**STAFF RESPONSE TO  
LONG TERM ELECTRICAL  
SUPPLY PLAN  
QUESTIONS, ISSUES, AND  
RECOMMENDATIONS**

MADE IN NOVEMBER 2004  
TO THE  
GAINESVILLE CITY COMMISSION

PREPARED BY  
GAINESVILLE REGIONAL UTILITIES  
DECEMBER, 2004

**Technical Review of Gainesville Regional Utilities Integrated Resource Plan  
By**

Figure 1 – Recent Electrical Power Needs Projections by GRU

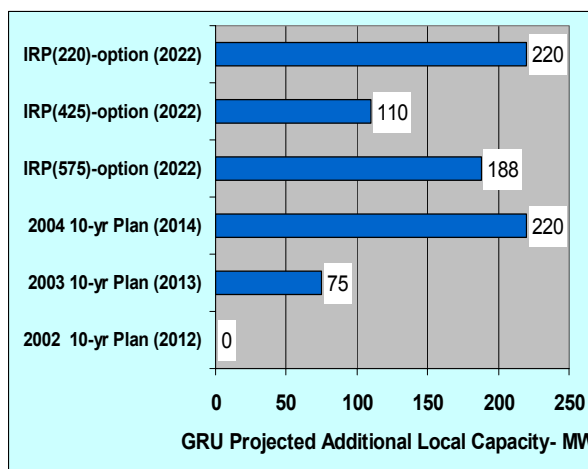
Evaluation of GRU summer peak load projections presented in the December 2003 GRU- IRP which explores alternatives to meeting requirements through 2022 shows that another addition of approximately 75 to 100 MW may be needed somewhere between 2015 and 2017. However, the December 2003 GRU-IRP and subsequent documents from GRU say that due to increasing demands for electricity, the need to retire older generating units, and the need for cost effective "baseload" capacity, a new solid fuel-fired unit approximately the same size as the existing coal-fired unit Deerhaven 2 (DH2) is needed. The proposed unit would use circulating fluidized bed technology to burn coal, petroleum coke, and other solid fuels. It appears that the proposed unit would be similar to the two 300 MW circulating fluidized bed units currently operated by Jacksonville Electric Authority. The reason for the sudden change in the magnitude of local electrical generation needs and the increased focus on a coal fired generating unit is not presented in the GRU documents.

- ***See comment above. The data in Figure 1 are taken out of context without including the other components of the alternative plans evaluated, which included components of gas fired and purchased power in addition to solid fuel capacity, and are therefore misleading.***

Figure 2. (Reference 12)

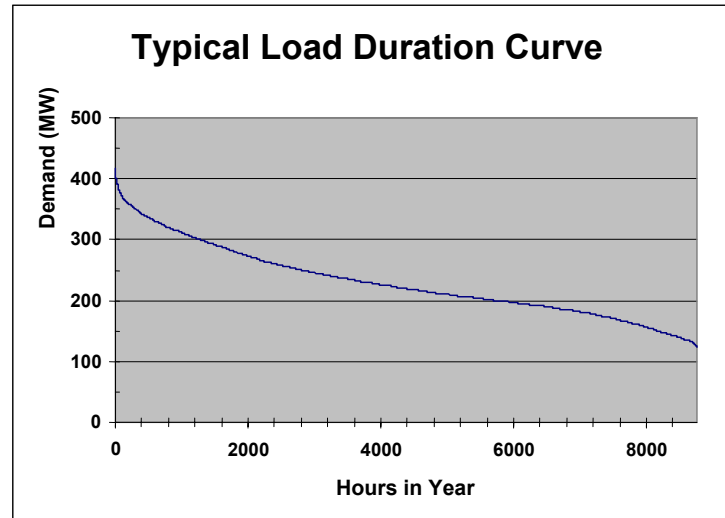
Typically, a load demand curve (Figure 2) with particularly steep slope at the high demand end (high load for a short percentage of time) indicates peaks are only occurring for a small number of time intervals. A flat curve in this region (more of a constant load) indicates the peaks occur over a substantial number of time intervals. If extra power is needed for only a few days a year it is obvious that purchasing power to meet the peaks will be much cheaper

than building and operating new capacity. On the other hand, if peaks extend over several months in a year, a new plant may well be worth the investment. The “peakiness” may also influence the type of plant that should be added to the system. GRU should further clarify feasibility of supplying portions of total load demand from outside sources by purchases as compared to building excess local capacity.

- *The above analysis is an incomplete depiction of how generation planning is performed. GRU has to consider all aspects of electrical supply, including reliability, fuel costs, base loads, peak demands, the age and condition of the generation fleet, and reserve margins. The various alternatives evaluated to date are not based solely upon peak demands and we have discussed these various factors many times over the last year.*

**Figure 3 ( from GRU-IRP Fig I-3)**  
Societal and Generation Costs for Selected Options

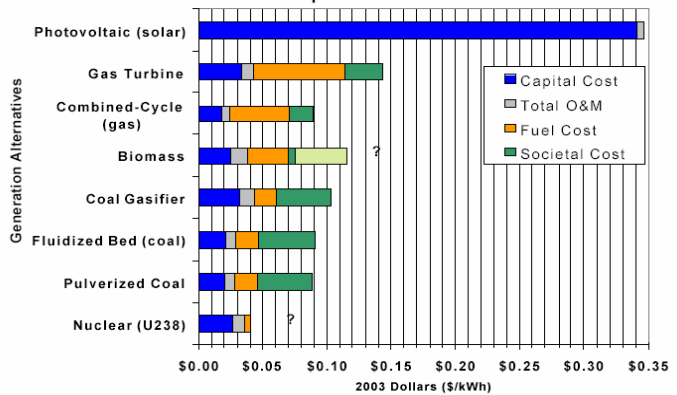
In Table I-5 of the IRP, the CCCT natural gas option is rated lower than coal for "reducing local emissions". This is inconsistent with the fact that natural gas generation has inherently lower emissions than coal. It appears that GRU assumed the retrofit of DH2 with additional pollution controls in the CFB coal evaluation but did not consider the retrofit of DH2 in evaluating the CCCT natural gas option. This option should be more fully evaluated and considered.

- **The analysis performed by GRU in response to questions during the public outreach process and documented in the December 2003 Planning document did not include the retrofit of Deerhaven 2 for any of the options. What this screening analysis demonstrated is that even after using the highest externality costs for NO<sub>x</sub>, SO<sub>2</sub>, particulate matter, and carbon dioxide imposed by any regulatory agency or state in the USA, the cost of the fuel outweighed the cost of the externalities (a carbon dioxide cost of \$40 per ton was applied).**

Figure 4 ( Slide 39, 12-15-03 GRU Presentation)

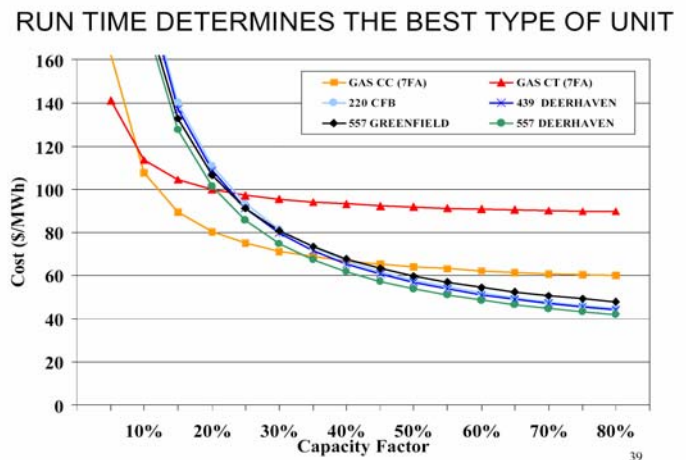
Operational costs are dependent upon run time or capacity factors. If one assumes that GRU operates a natural gas powered CCCT as a baseload unit with a capacity factor similar to the existing DH2 and the proposed CFB plant (70% to 85%), then the costs per MWh (Figure 3) for both technologies are relatively close (approximately \$50/MWh for CFB and \$60/MWh for CCCT(CC7FA)).

Although the operational cost for using a CCCT is more than that of a equivalent coal fired unit, the emissions reductions in NO<sub>x</sub>, SO<sub>2</sub> and PM that could be achieved by building a CCCT unit instead of a CFB unit are considerable. Reduced costs for additional pollution control equipment on a coal plant could possibly offset some of the increased fuel costs for a CCCT plant. Natural gas prices may also be more competitive with coal/pet-coke prices in the future due to increasing supply and possible carbon taxes on coal. These factors may make the construction of a CCCT plant a more cost feasible option. This approach should be further evaluated and considered by GRU.

- **This slide demonstrates that even at high capacity factors, CCCT alternatives are more expensive to operate. The voluntary Deerhaven 2 retrofit portion of GRU’s proposed plan is also designed to meet potential new regulations. Accordingly, GRU does not recommend a lower cost emission control scenario for the Deerhaven 2 retrofit.**

**Figure 5. Estimated SO<sub>2</sub> and NO<sub>x</sub> emissions from Future Controlled DH2 and CFB**

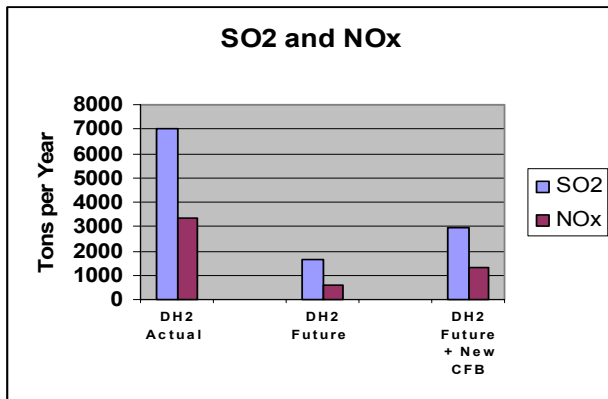
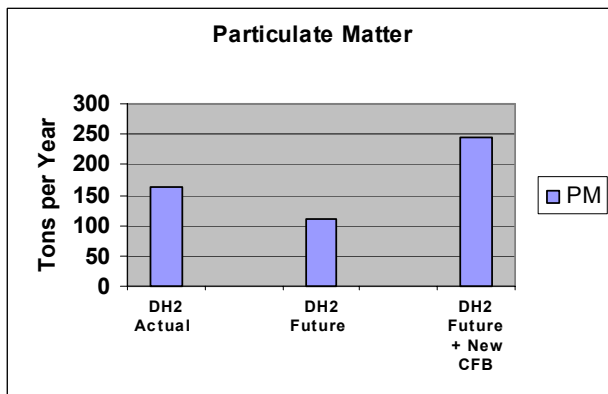
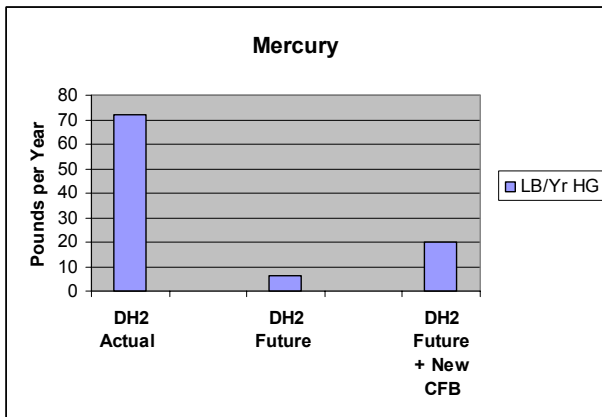
The proposal to add a 220 MW coal/petcoke fired power plant will add a major new air pollution source to Alachua County. If GRU were to install the proposed emission controls on the coal fired DH2, air quality would be improved by reductions in SO<sub>2</sub> and NO<sub>x</sub> and PM. Installing a new additional coal/petcoke unit at Deerhaven will increase the pollution levels again but the total emissions of SO<sub>2</sub> and NO<sub>x</sub> and PM will still be less than those of the current DH2 plant. **Figures 5, 6 and 7** show the estimated changes in SO<sub>2</sub>, NO<sub>x</sub>, PM<sub>10</sub> and Mercury emissions projected for the future controlled DH2 and new CFB plant.

- *Under the proposed plan, GRU will voluntarily commit to install emission controls on Deerhaven 2 as part of an overall expansion project to capture economies of scale (construction and operation cost savings) by combining the retrofit with the construction of a new unit.*
